City of Biddeford
Planning Board
December 20, 2023 6:00 PM City Hall
Council Chambers, & Zoom
<https://biddeford.zoom.us/j/94983531202?pwd=Q3ZyejcyUVpBaUVVMHduYXJhSzB4UT09>
Webinar ID 949 8353 1202; Passcode 223739

Case 2023.44: Preliminary Site Plan Review for Everybody Loves Raymond St, LP / Proposed Construction of a 10-unit residential structure on Raymond Street (Tax Map 29, Lot 108).
Planning Board Hearing date: December 20, 2023.

Per your request Site Design Associates has undertaken a review of the plans and documentation submitted in support of a site plan application for the referenced project. Our review was based on preliminary civil engineering plans dated 11-22-23.

R-TANK^{HD} SYSTEM OVERLAY
BERRY PARK EXPANSION
BIDDEFORD, ME

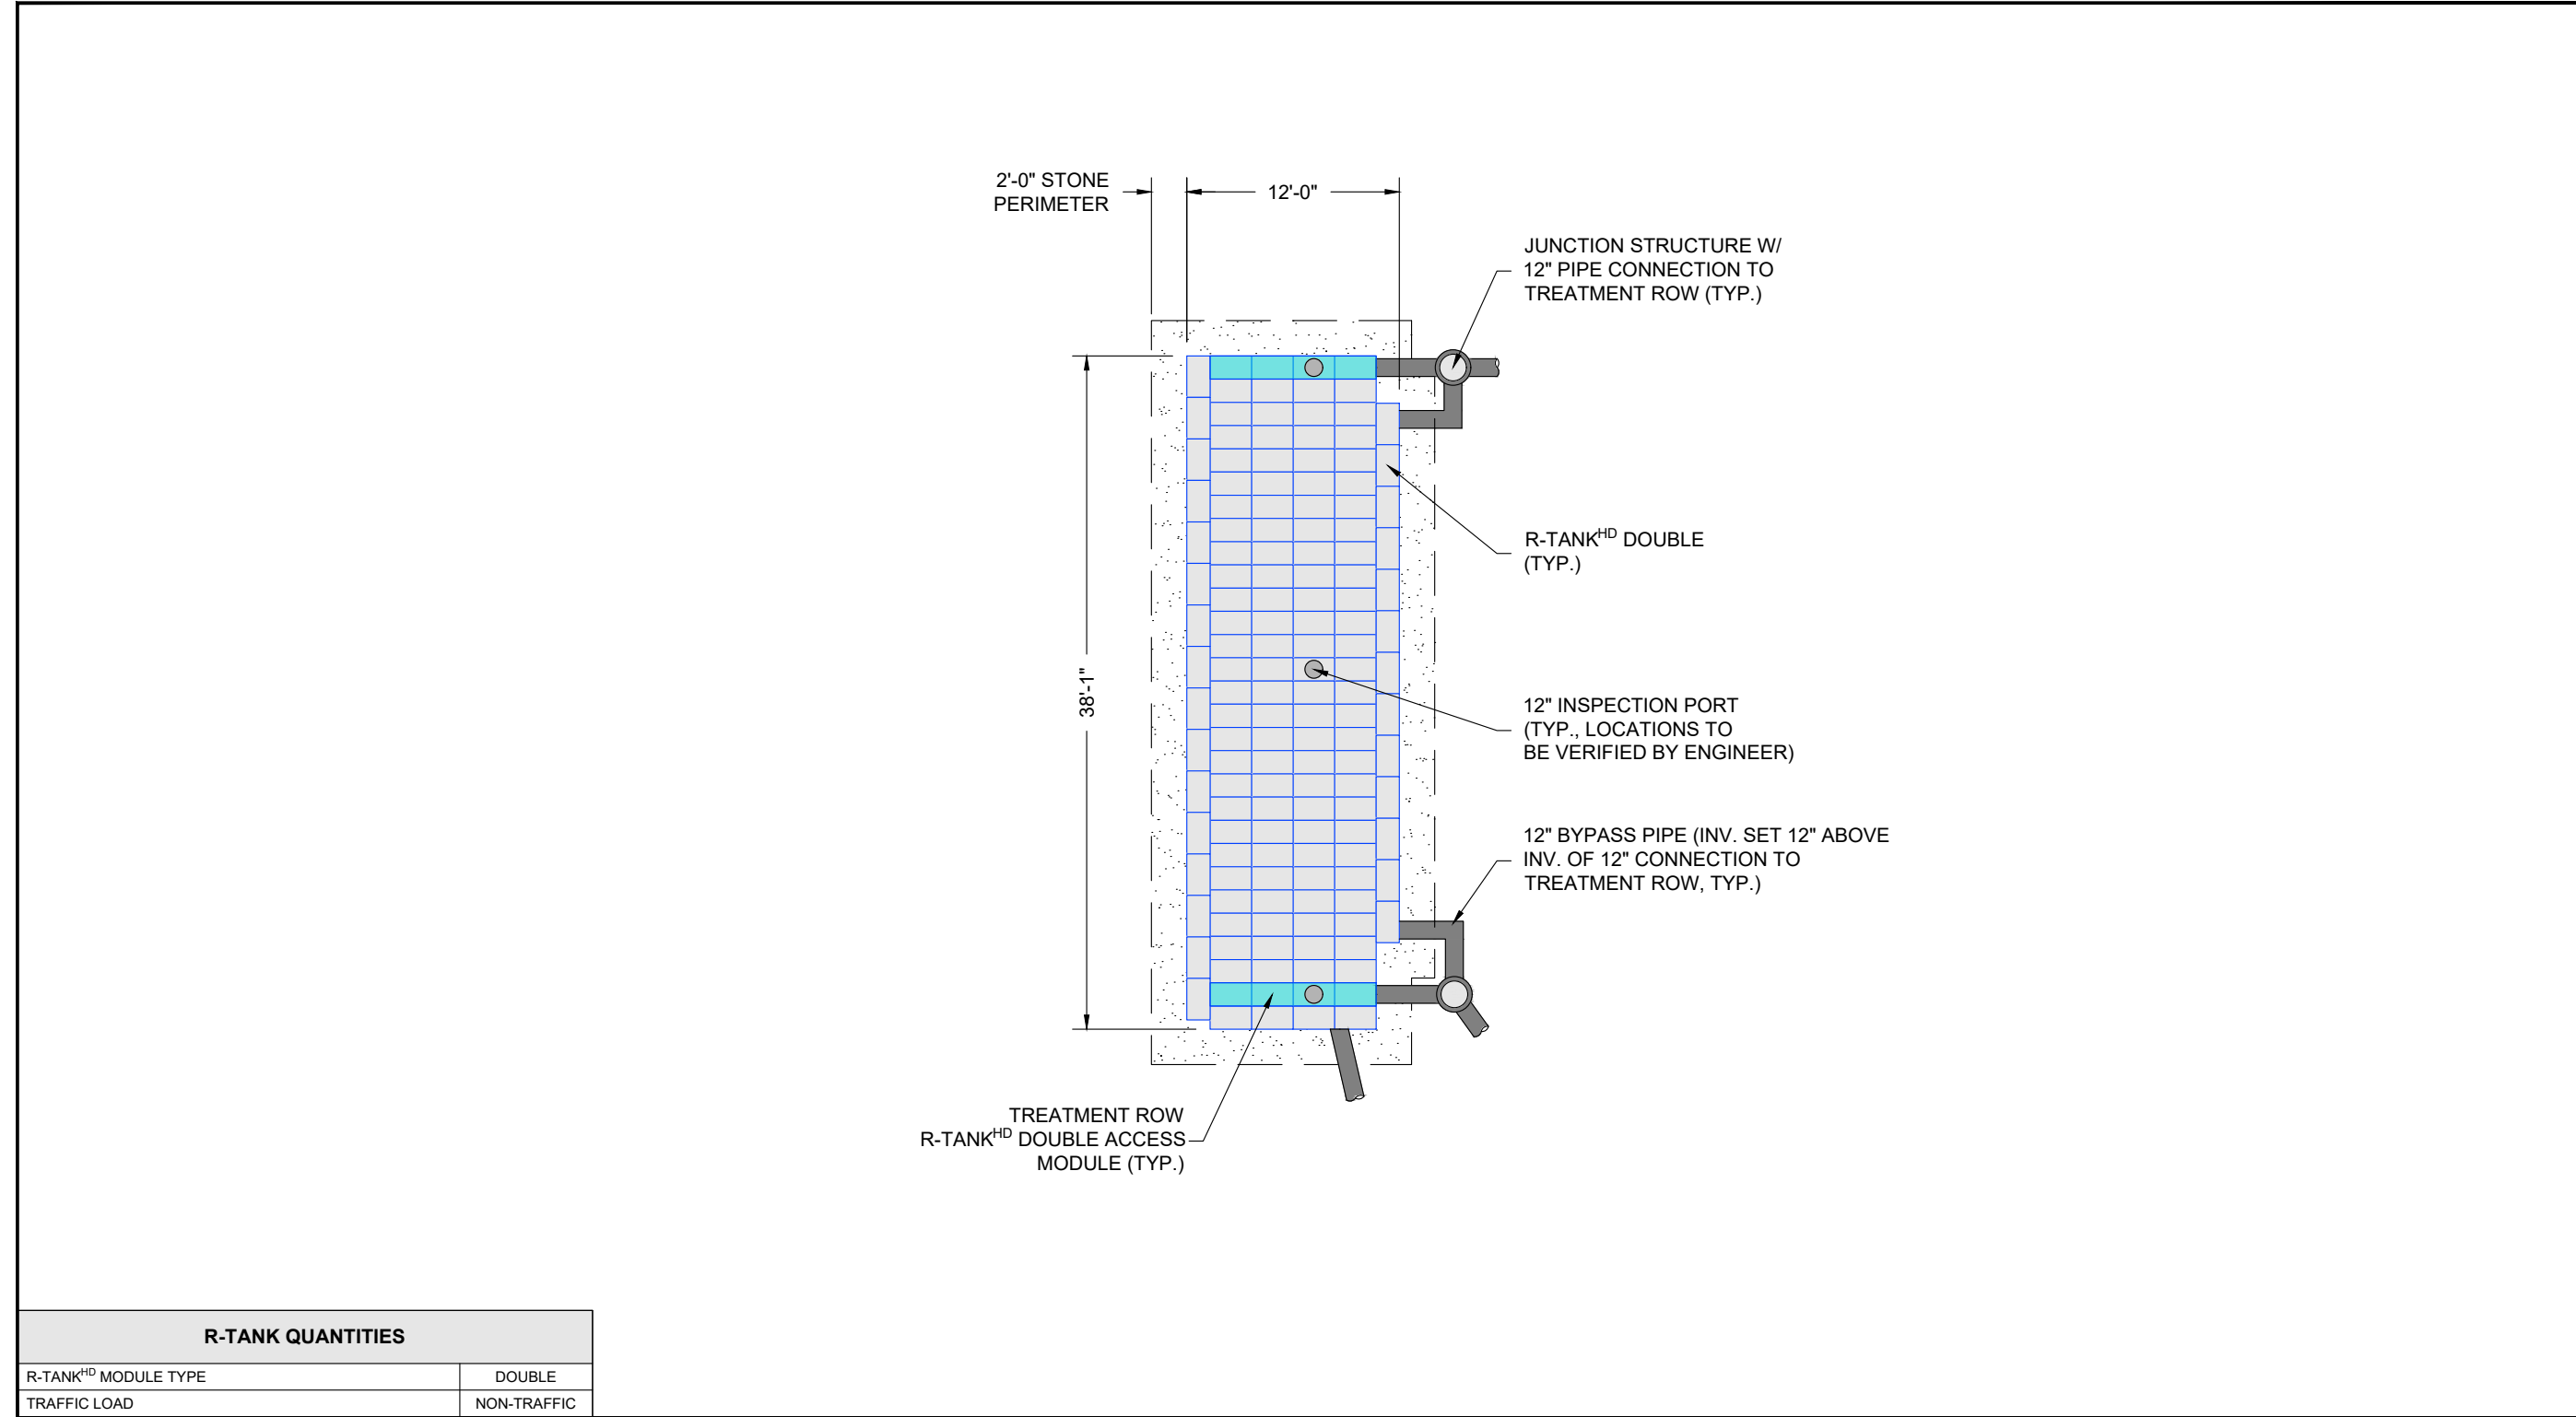
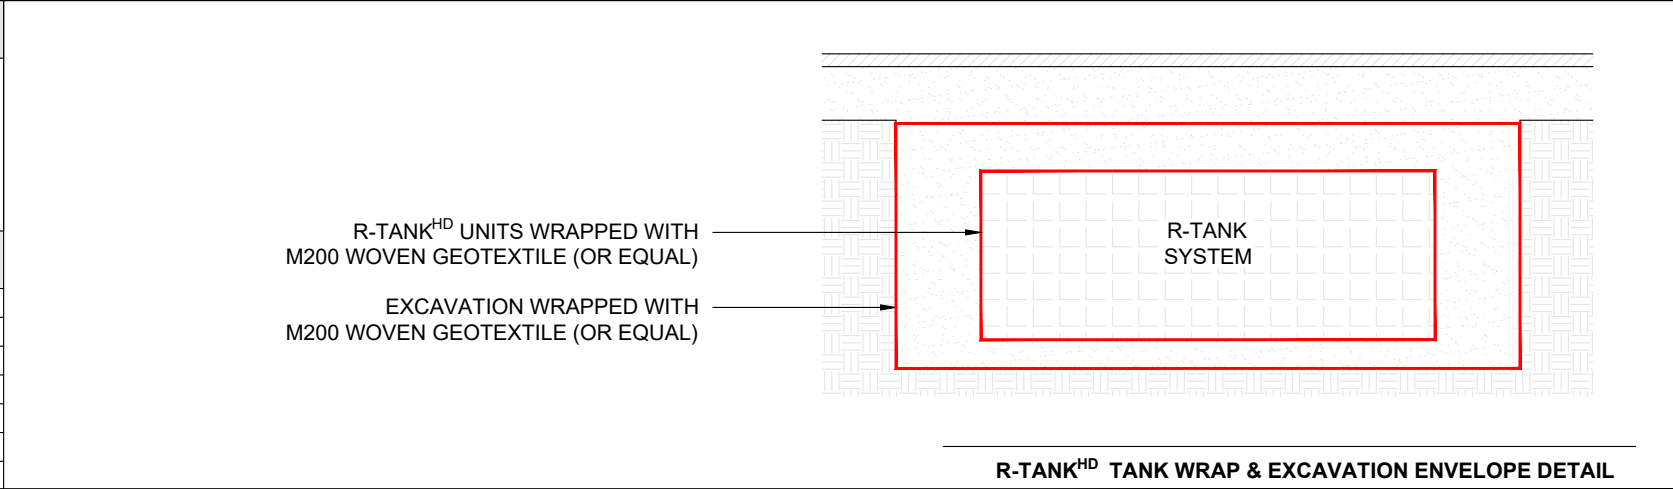
8. The R-Tank size and layout as shown in the report conflict with the information shown on the drawings.
9. The times of concentration paths for SC-11 and SC-12 differ from that used in the model. Also, as noted above the sheet flow component should change to a shallow concentrated flow component where there is a direction change and/or swale.

PROJECT: BERRY PARK EXPANSION 27-81 RAYMOND STREET, BIDDEFORD, ME	CLIENT: EVERYBODY LOVES RAYMOND ST, LP 17 SOUTH STREET, 3RD FLOOR PORTLAND, ME 04101
SHEET TITLE: EXISTING CONDITIONS & DEMOLITION PLAN	
DATE: 8/23/2023	
SCALE: 1" = 10'	
JOB NO: 20-68	
SHEET:	C-2.0

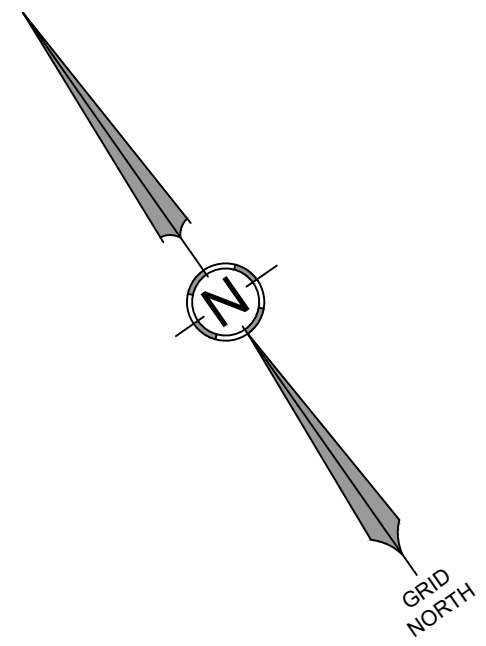
1. Existing Conditions and Demolition Plans
 - a. A benchmark should be provided.
 - b. The plan should be updated with additional existing conditions information for the stormdrain systems in Raymond Street and Debbie Avenue. The majority of the runoff is being routed to an existing system in Debbie Avenue, but little information relative to this system is provided. Additionally, the city GIS system shows the two catch basins in Raymond

Street connected, and outletting to a pipe in the north side of Raymond Street. Does the underdrain shown at CB 1063 run as noted on the drawing?

- c. Based on the grading plan, it appears the six trees along the southerly property line will also be removed and if so, should be shown as such.
